PROJECT: Advanced Boiling Water Reactor (ABWR)

SUBJECT: SUMMARY OF MEETING WITH GE ON SEPTEMBER 21-22, 1992

A public meeting was held between the Nuclear Regulatory Commission (NRC) staff, GE Nuclear Energy (GE), and the Nuclear Materials Resources Council (NUMARC) at the offices of GE in San Jose, California, on September 21-22, 1992. The purpose of this meeting was to discuss issues related to the industry and staff review of the ABWR inspections, tests, analyses, and acceptance criteria. Enclosure 1 is a list of those who attended.

Figure 2.2.6 Rem. Shutdown System

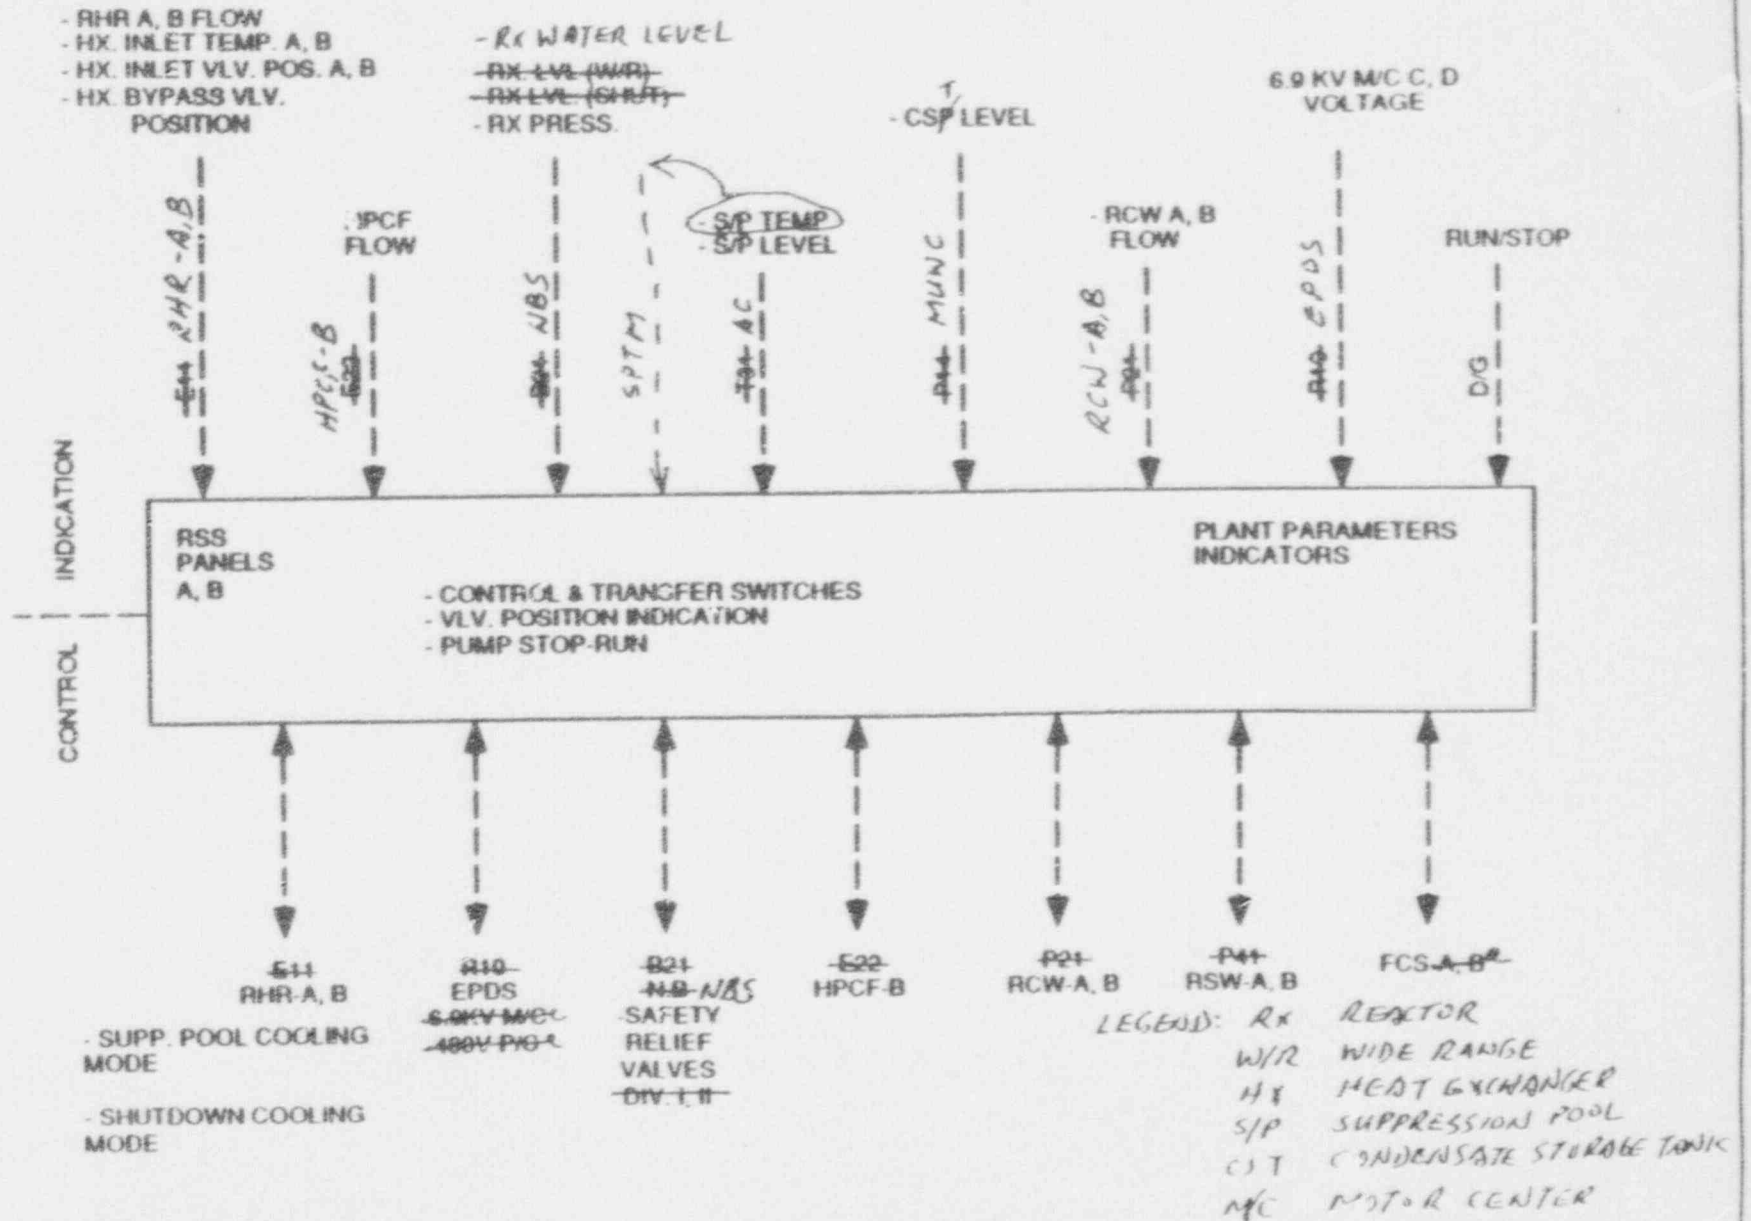
~~No Loss of Coolant Accident (LOCA), seismic event, or other abnormal plant condition, except loss of off-site power, is assumed to occur coincident with the event requiring the main control room evacuation.~~ The RSS has two divisional panels and associated controls and indicators for ~~monitoring~~ <sup>INTERFACING WITH</sup> the following interfacing systems:

<sup>TO CONDUCT THE PLANT SHUTDOWN</sup> Indication for plant parameters is also provided on the remote shutdown panels ~~to assure a safe and controlled shutdown of the plant.~~ Figure 2.2.6 shows the RSS with the interfacing systems and control and indication functions provided.

Certified Design Commitment	AND INDICATORS FOR	Inspections, Tests, Analyses	Acceptance Criteria
1. RSS provides remote manual control of the following interfacing systems to bring the reactor to cold shutdown conditions, DEFINED IN SECTION 2.2.6: a. RHR (pool-cooling and shutdown-cooling mode) b. HPCF c. NBS Safety Relief Valves d. RSW e. RCW f. EPDS <del>g. AG</del> <del>h. DIG</del> <del>i. MUWE</del> j. FCS		1. Review of as-built documentation and visual inspections of the RSS will be performed. <del>Testing of the RSS control functions will be performed.</del> TO VERIFY THE PRESENCE OF CONTROLS AND INDICATORS ON THE RSS PANELS.	1. RSS has the required plant system controls <del>capability.</del> AND INDICATORS ON THE PANELS FOR THE SYSTEMS LISTED IN THE CERTIFIED DESIGN COMMITMENT DEFINED IN SECTION 2.2.6.

2. RSS PROVIDES INDICATIONS OF PLANT PROCESSING PARAMETERS DEFINED IN SECTION 2.2.2 FOR THE FOLLOWING SYSTEMS: a. AC b. DIG c. MUWC d. JPTMS		2. INSPECTIONS OF THE RSS WILL BE PERFORMED TO VERIFY THE PRESENCE OF INDICATIONS ON THE RSS PANELS.	2. RSS HAS THE INDICATIONS ON THE PANELS FOR THE SYSTEMS LISTED IN THE CERTIFIED DESIGN COMMITMENT DEFINED IN SECTION 2.2.6.

Figure 2.11.6a HECW Division - A

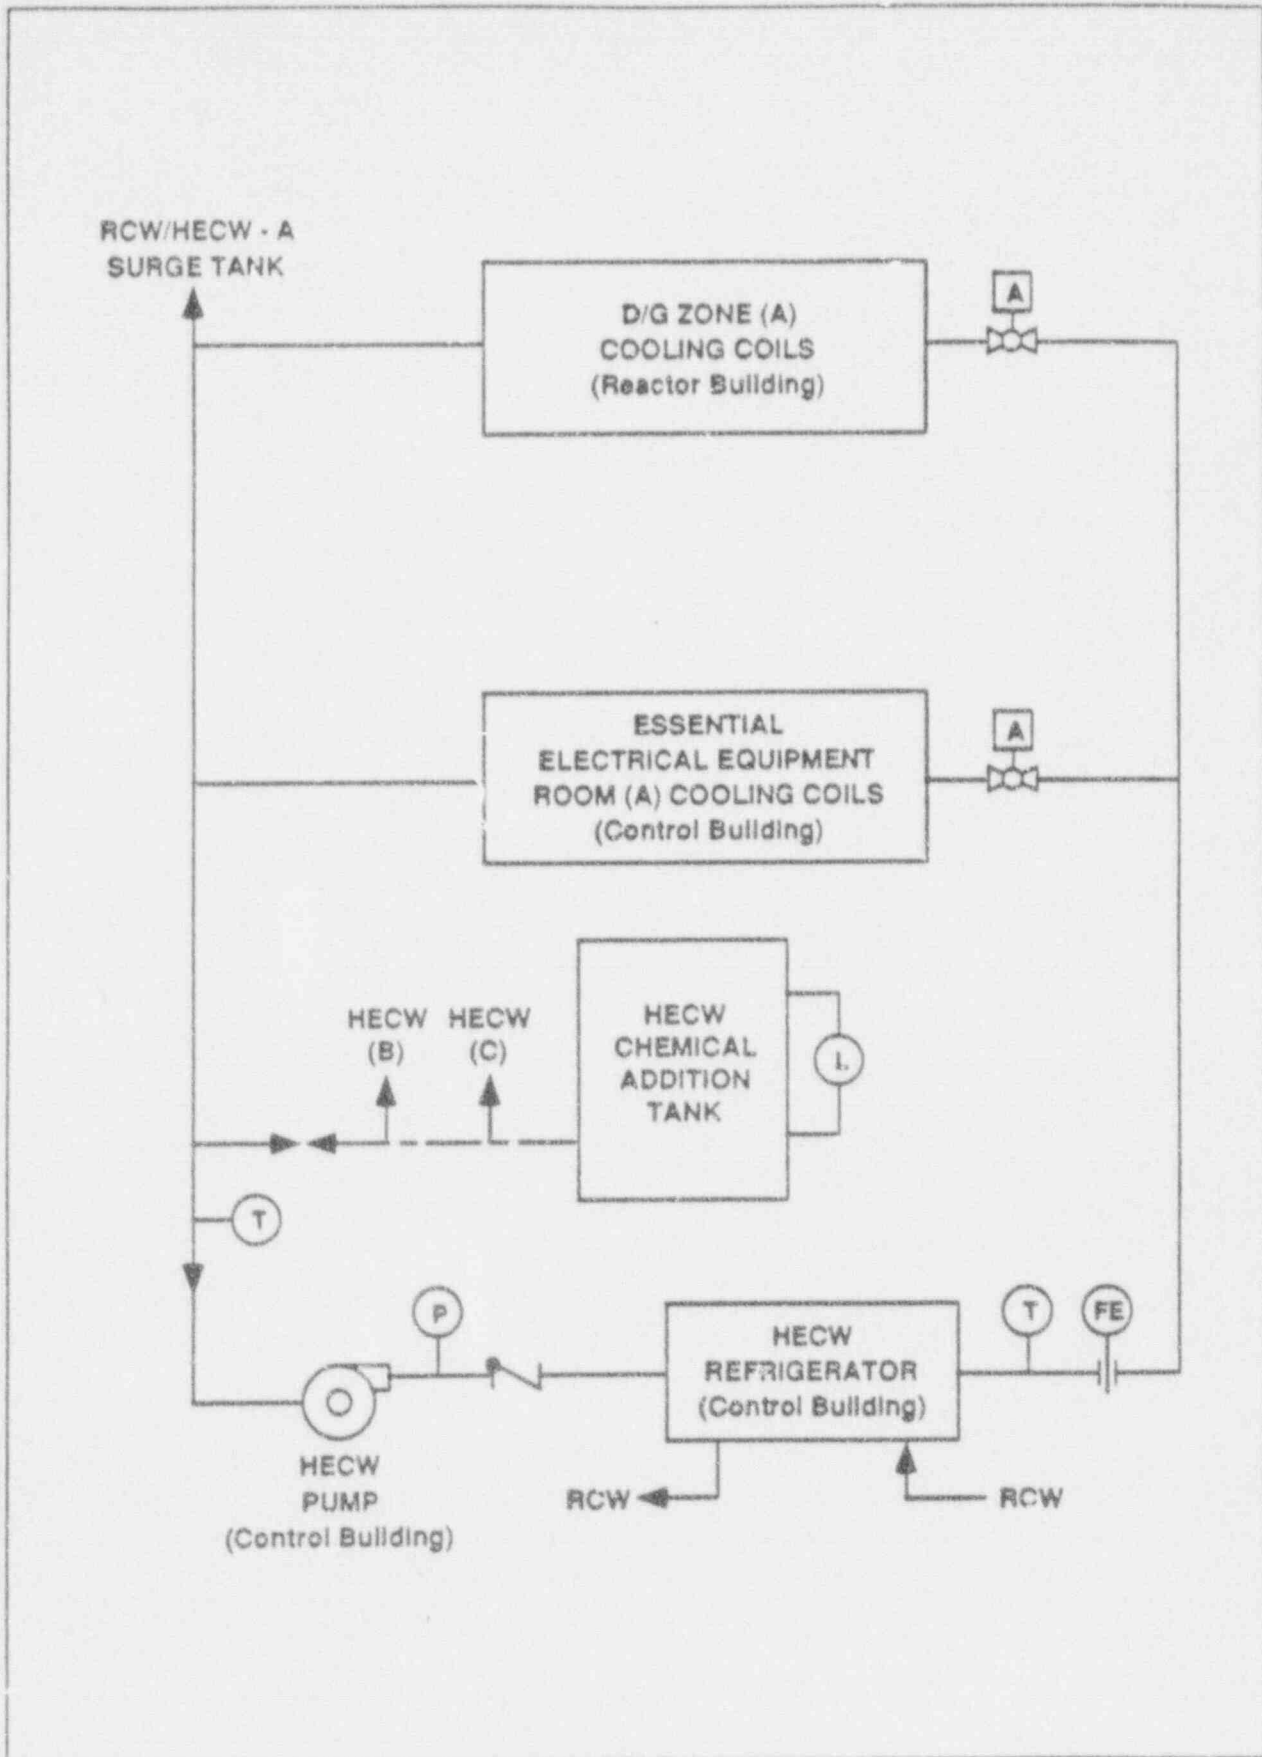
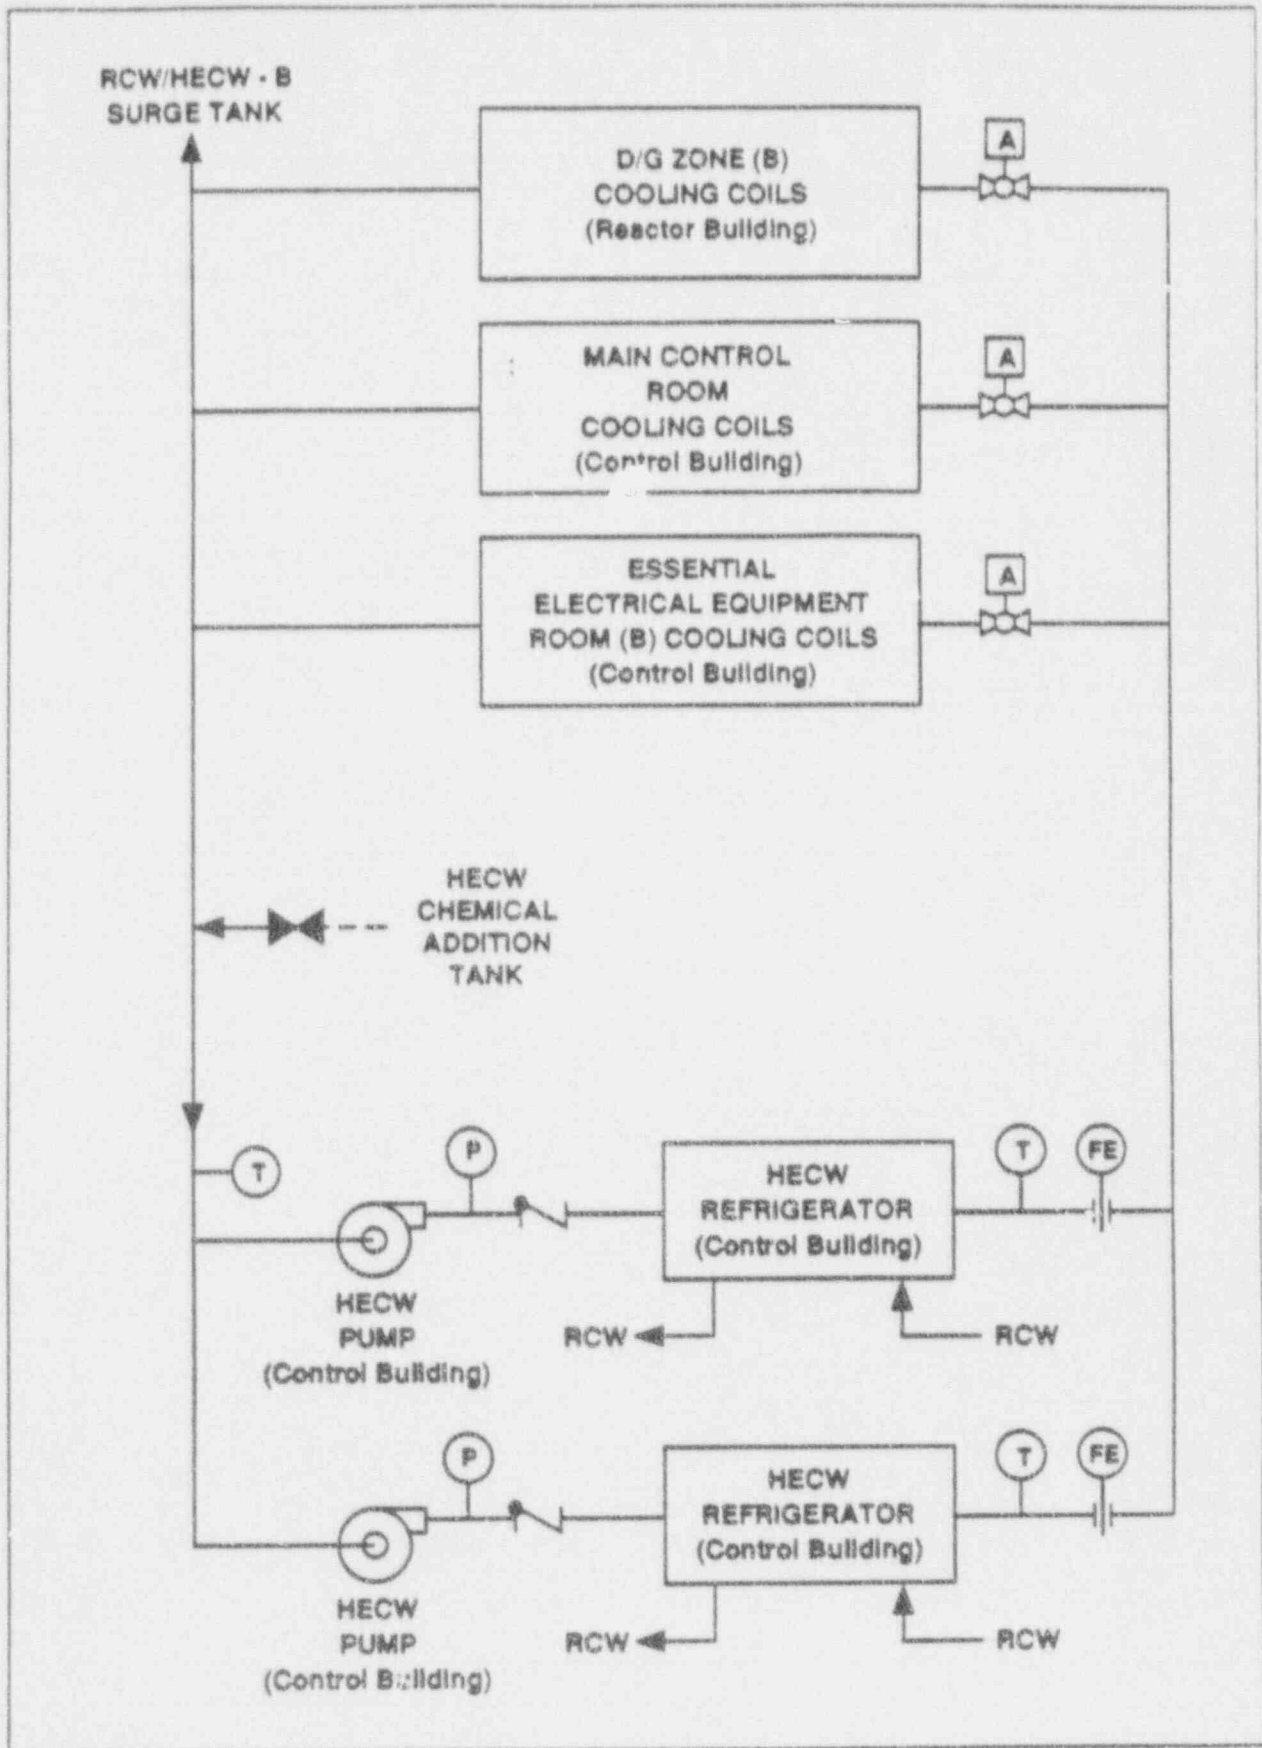
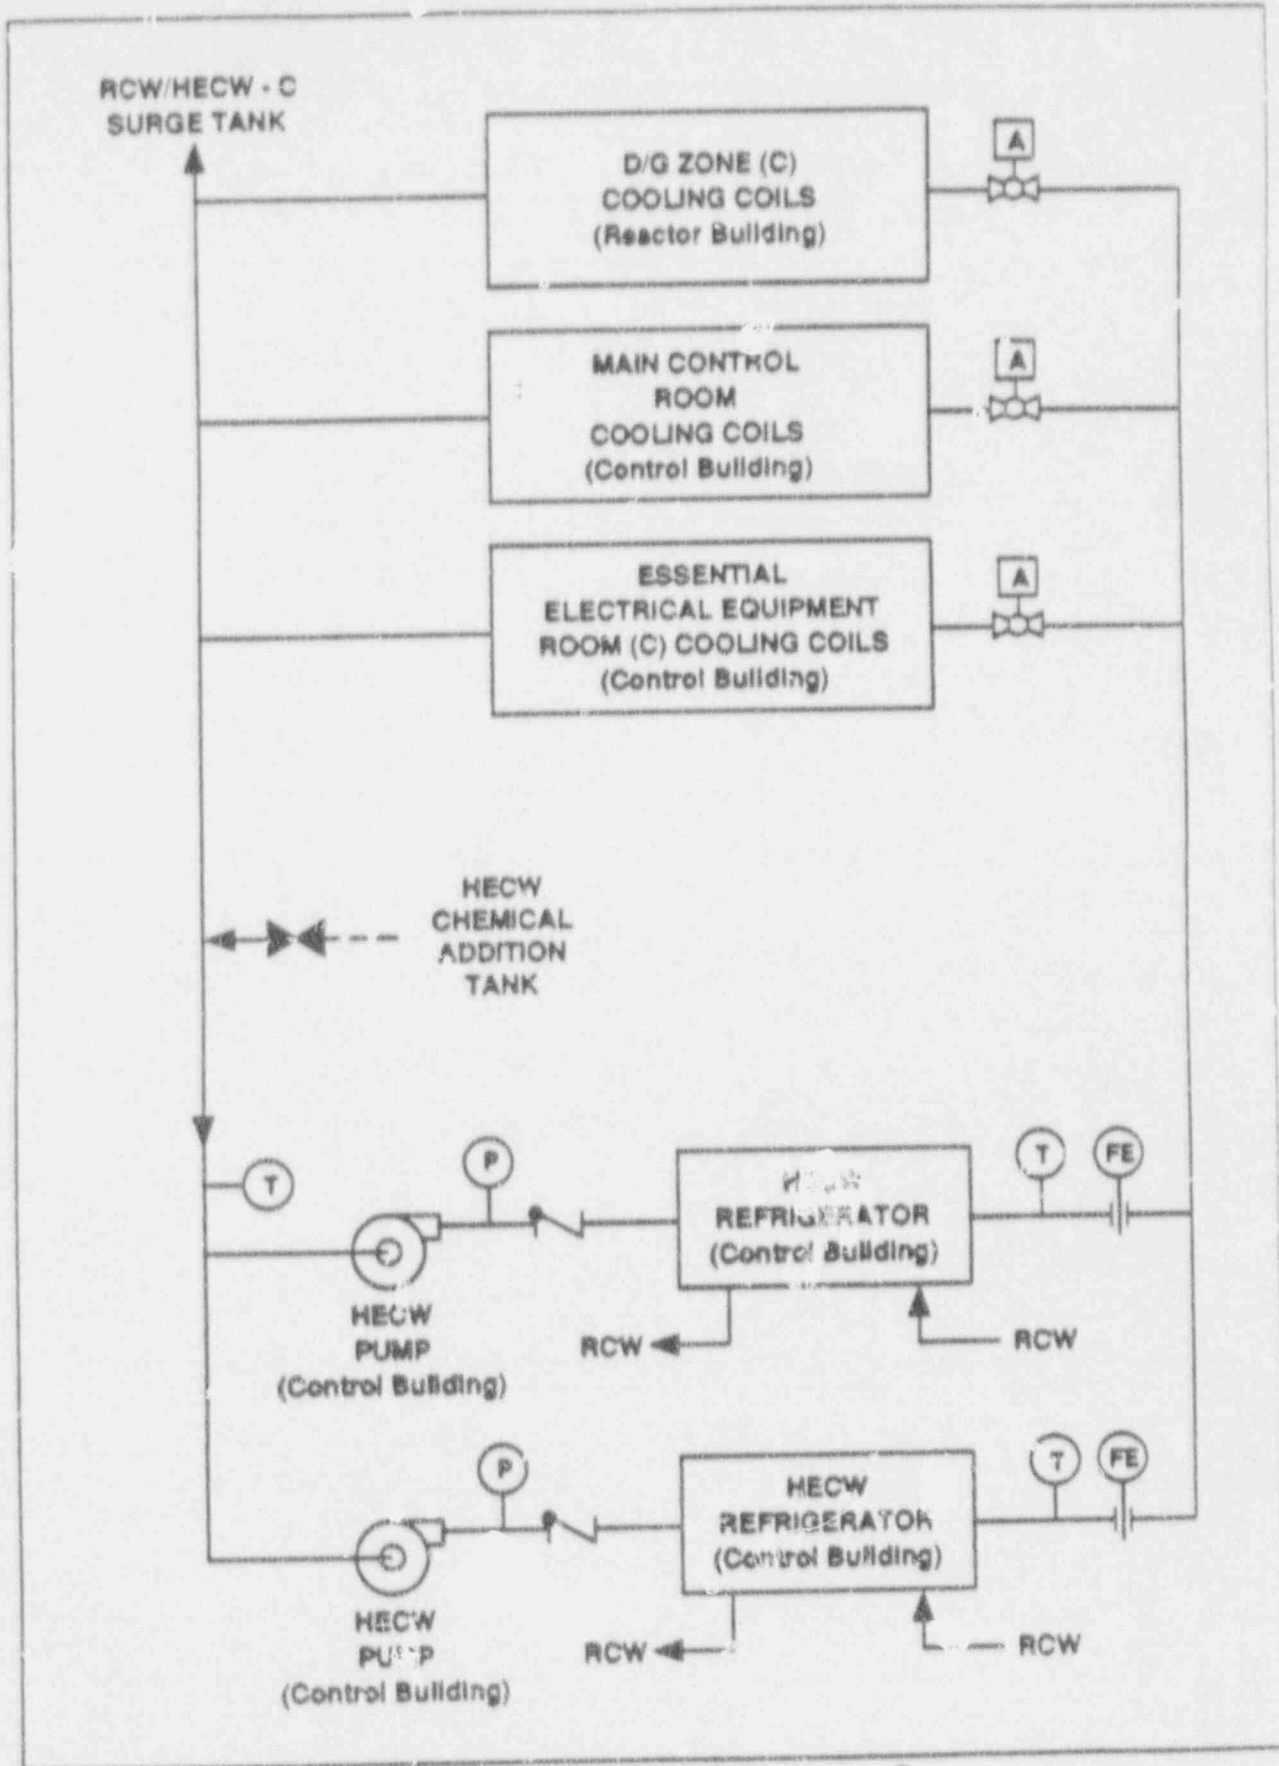
Certified Design Commitment	Inspections, Tests, Analyses	Acceptance Criteria
<p>1. The system configuration includes key components and flow paths as shown in Figure 2.11.6. SEE 2.11.6 3a</p> <p>2. The HECW divisions are mechanically and electrically independent.</p> <p>The HECW divisions are powered by independent Class 1E sources. SEE 2.11.6 3b</p>	<p>1. Inspection of construction records will be performed. Visual inspection (VI) will be performed based on Figure 2.11.6. SEE 2.11.6 3a</p> <p>2. Tests and VI of the divisions will include independent and coincident operation of the three divisions to demonstrate complete divisional separation. VI will check for independent Class 1E power sources. SEE 2.11.6 3b</p>	<p>1. The system configuration conforms with Figure 2.11.6. SEE 2.11.6 3a</p> <p>2. Plant tests and VI confirm proper independence of each HECW division. VI confirm Class 1E power sources for each HECW division. SEE 2.11.6 3b</p>

<p>3. The standby refrigerator and pump units automatically start upon <sup>AT THE HIGH</sup> high temperature cooling water <sup>SET-POINT</sup> or failure of the operating units.</p> <p>The refrigerator units can be controlled individually from the main control room.</p>	<p>3. Tests simulating high temperature cooling water and operating pump failure will be conducted for each refrigerator and pump unit in divisions "B" and "C". Tests simulating main control room switch signals will be conducted for the refrigerator units.</p>	<p>3. Refrigerator and pump units acting as standby units start upon a high temperature cooling water or operating pump failure signal. Refrigerator and pump units <sup>INSERT #1</sup> are operable from main control room signals.</p>
<p>4. The HECW cooling capacity is capable of removing the heat loads on the system.</p>	<p>4. Inspections of vendor documentation will include refrigeration and pump capacities. Flow tests will confirm that adequate flow <sup>INSERT #2</sup> is available to the system.</p>	<p>4. Each refrigeration unit shall have an <math>\leq 5.8 \text{ MW}</math> effective heat removal capacity of <math>2.3 \times 10^8 \text{ kcal/hr}</math> at <sup>96.9 lpm</sup> 256 gpm. Each pump is capable of delivering <sup>96.9 lpm</sup> 256 gpm to the system.</p>

INSERT #1: OPERATE UPON RECEIPT OF  
INSERT #2: AND HEAT REMOVAL
